ADDENDUM NO. 1

This addendum modifies the Contract Documents dated December, 2022, for the San Lorenzo Valley Water District Redwood Park Pipeline Project, and the work shall be accomplished in accordance with such modifications. This Addendum includes two (2) pages plus three (3) attachments (total of 13 pages).

REDWOOD PARK PIPELINE

C-1.1

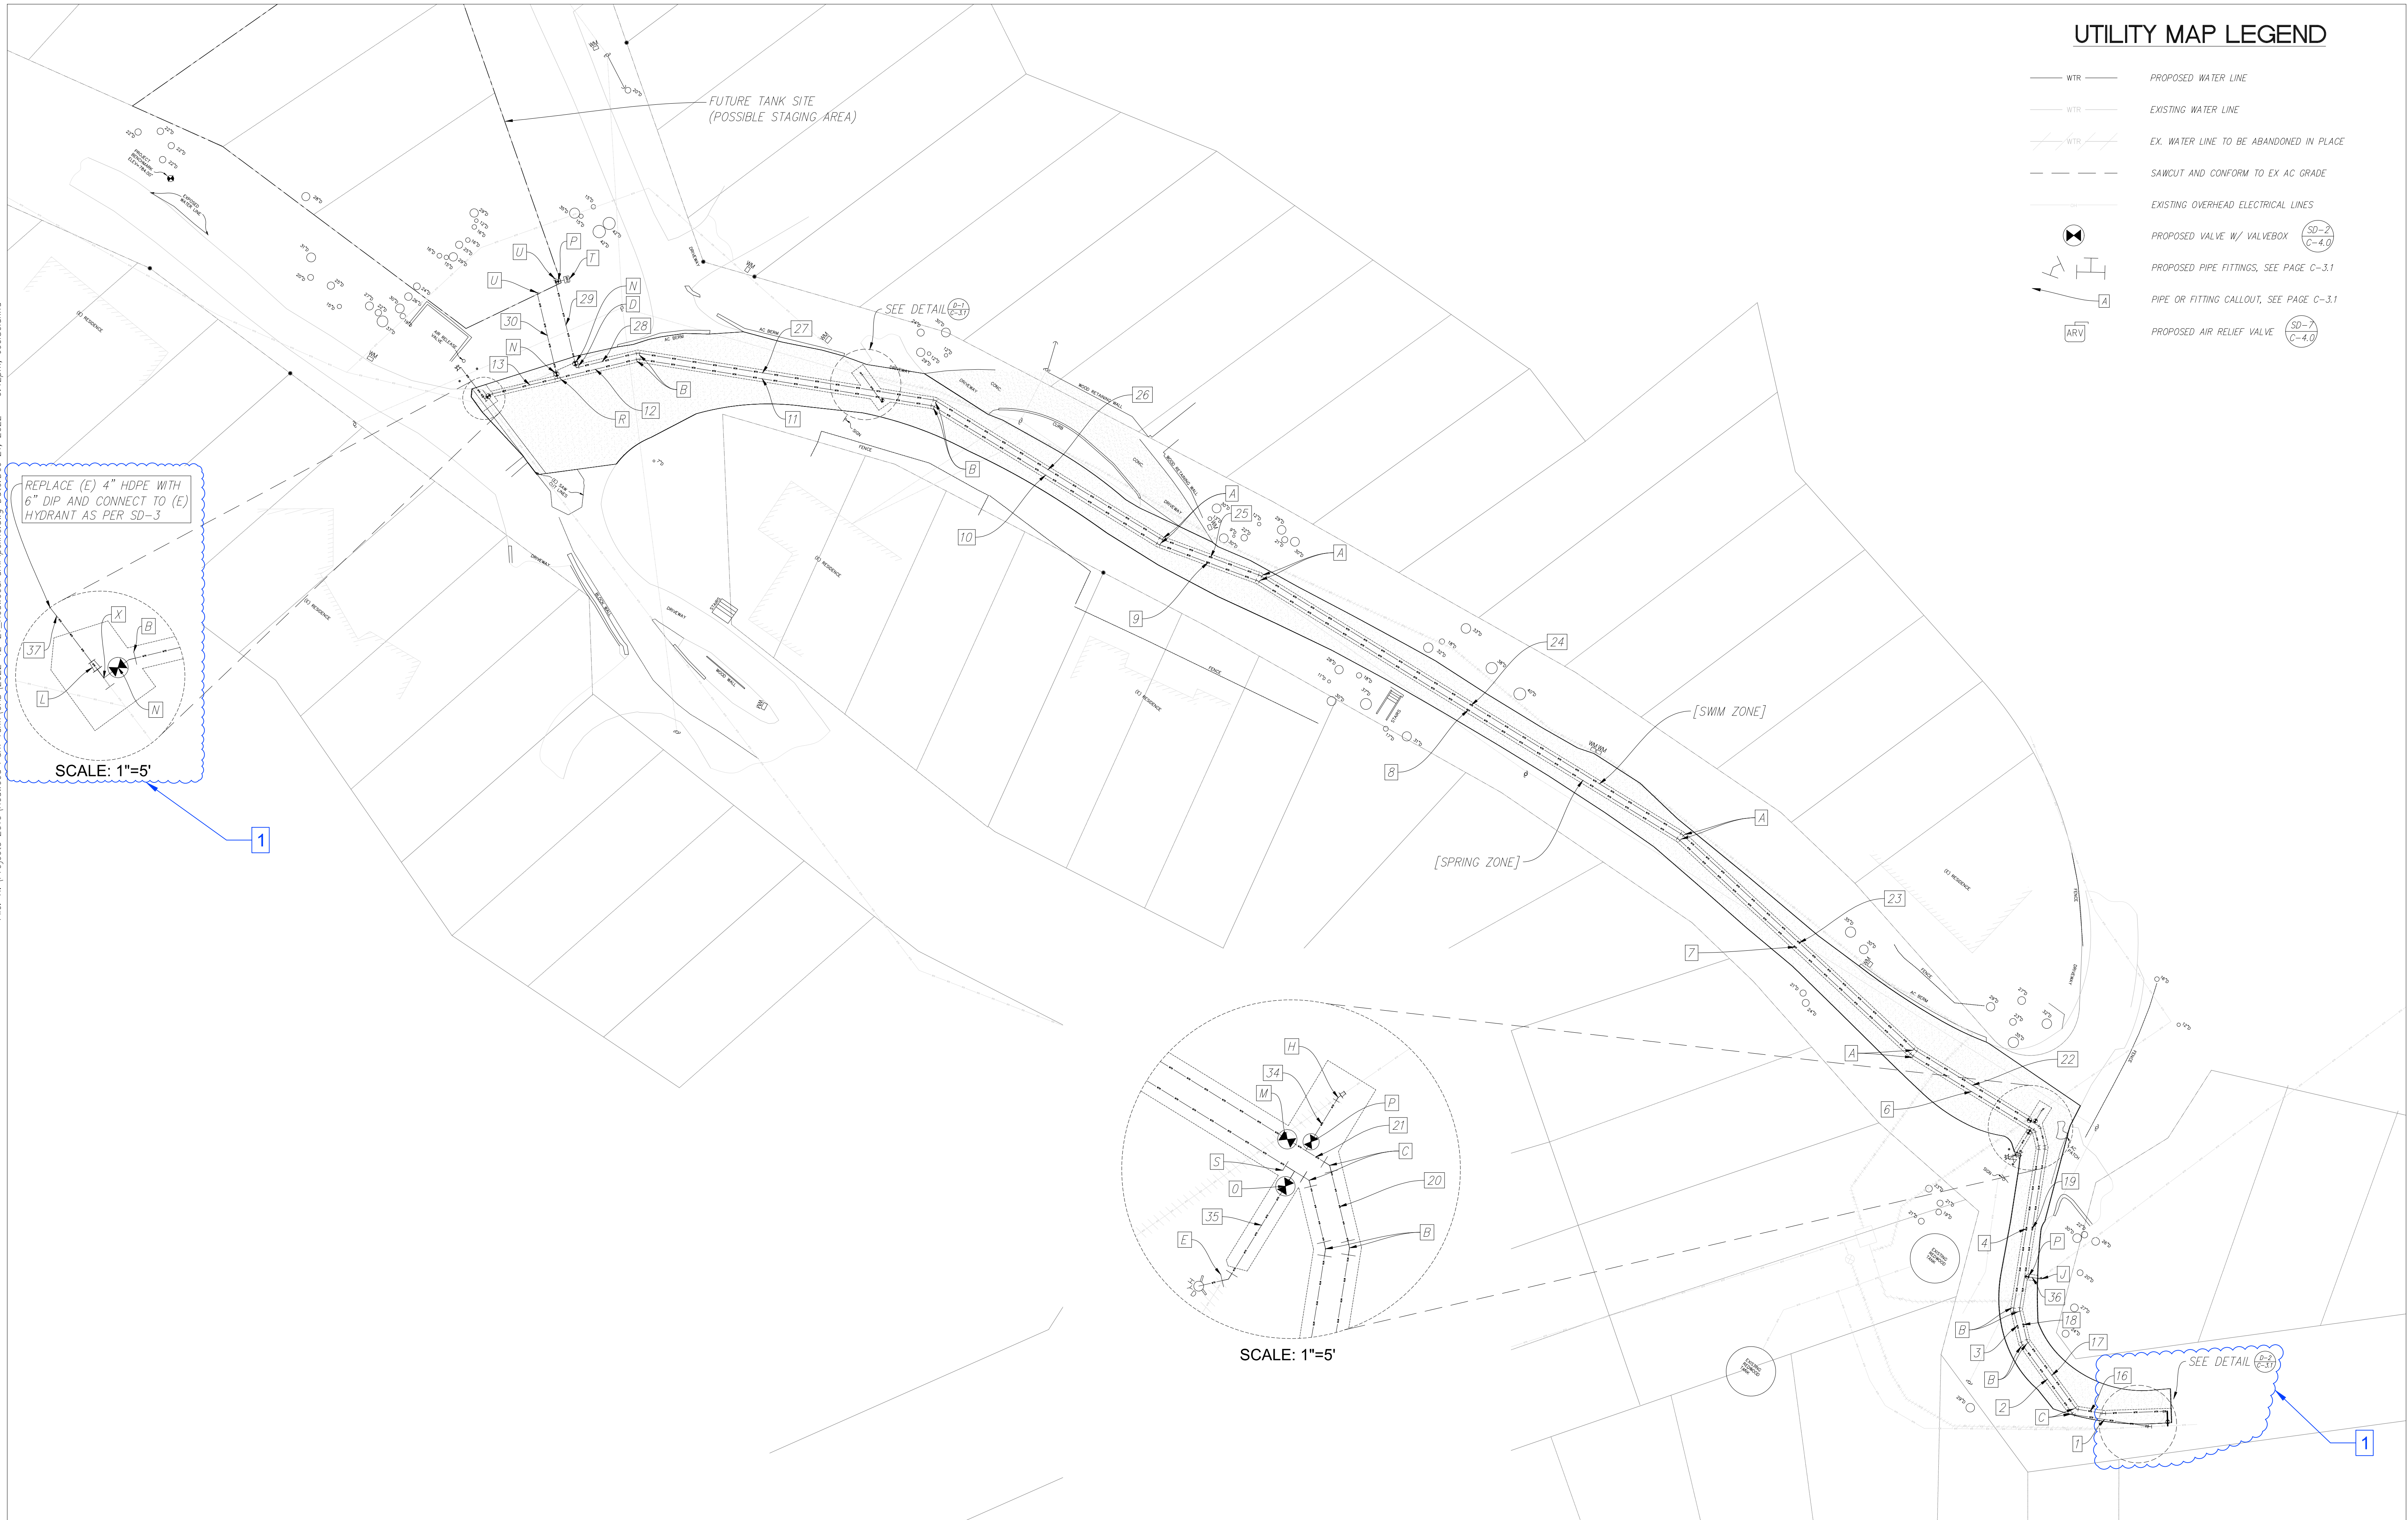
- A. Sheet C1.1, Pipeline Notes, Pipeline Note Number 23 is added, as follows:

“23. Minimum wall-to-wall separation between pipes is to be 12-inches, unless otherwise specified.”
- B. Sheet C3.0, Proposed Site Plan is revised. The changed sheet is attached.
- C. Sheet C3.1, Proposed Details is revised. The changed sheet is attached.
- D. Sheet C4.0 Utility Details is revised. The changed sheet is attached.

- MINIMUM WALL-TO-WALL SEPARATION BETWEEN PIPES IS TO BE 12-INCHES, UNLESS OTHERWISE SPECIFIED.
